REPORT TO COUNCIL

Application: DVP15-0301

Address: 1088 Sunset Dr.

Subject: Development Variance Permit

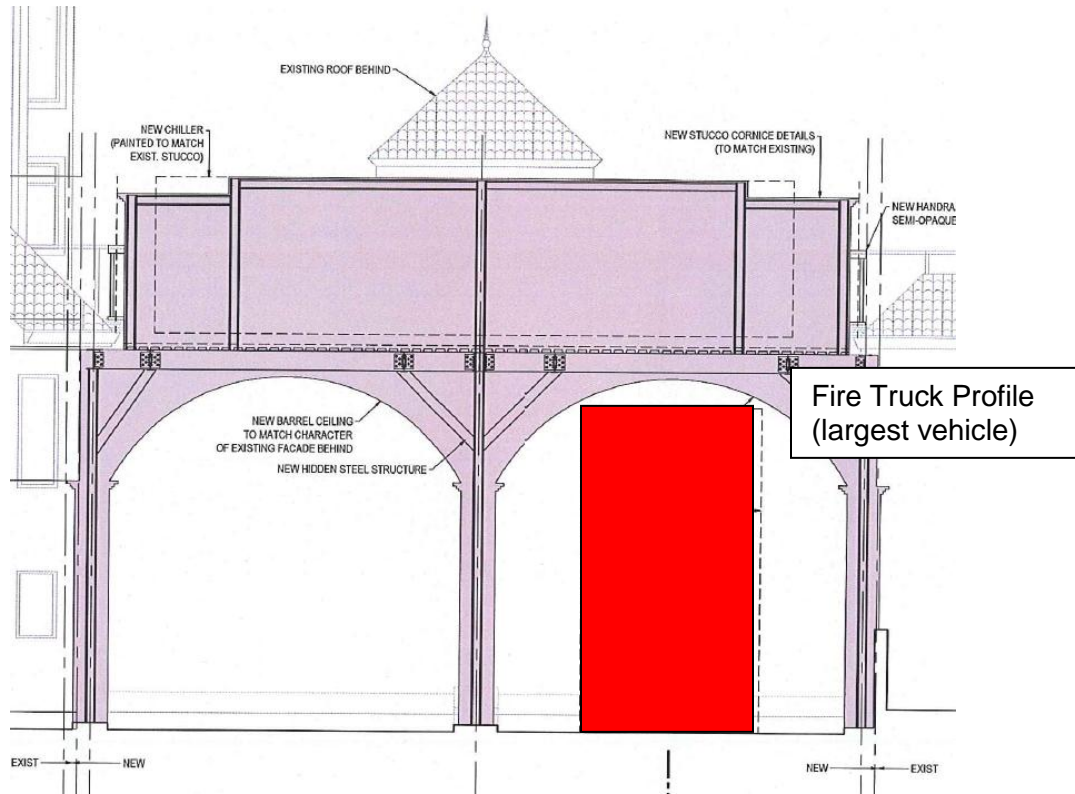
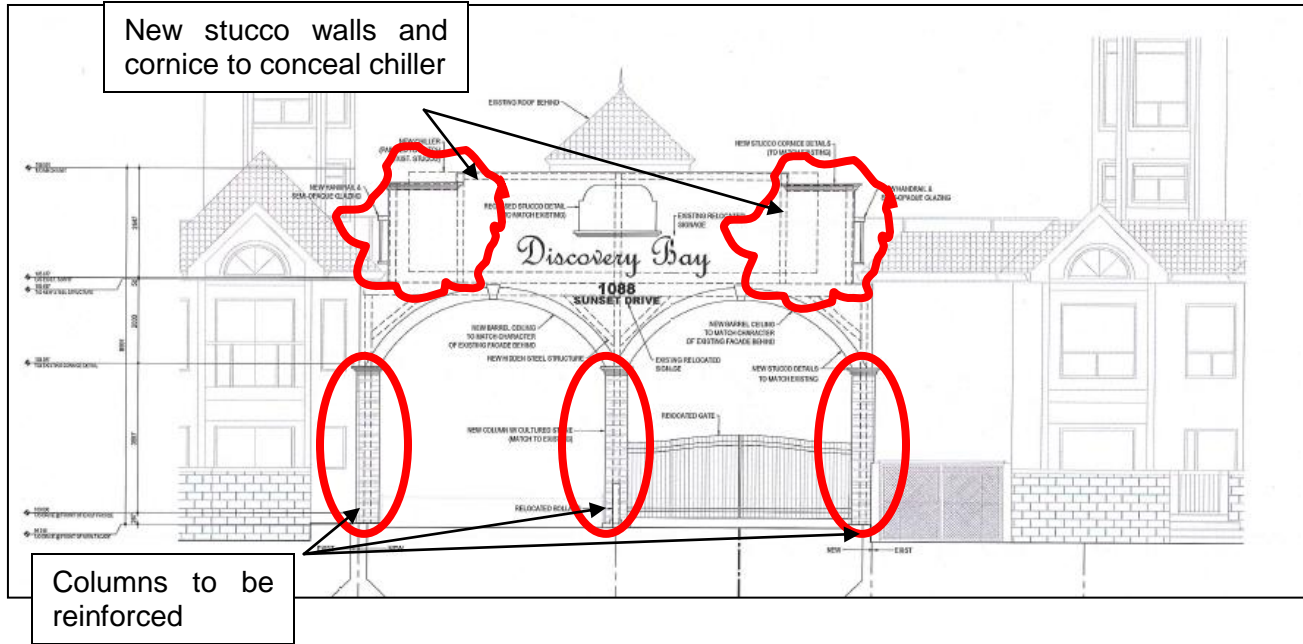
Because of the size and weight of the chiller, the entry structure will need to be reinforced. As consequence of this reinforcement, the pillars around the drive aisles will be expanded, reducing the drive aisle width from 5.6 m to 5.3 m. The minimum required drive aisle width per the Zoning Bylaw is 6.0 m.

- 1) Dimensions of opening to be verified with the fire department to allow for access.

- 1) This development variance permit application to vary the drive aisle to the parkade does not compromise any municipal services. It is suggested that the appropriate warning/information signage be posted for traffic entering this narrow drive aisle.

- 1) After a discussion with the engineer, we are satisfied that KFD's largest apparatus shall be able to access the ramp - both the width and height variance is acceptable.
- 2) Ensure that during construction, this width is maintained in case of an emergency
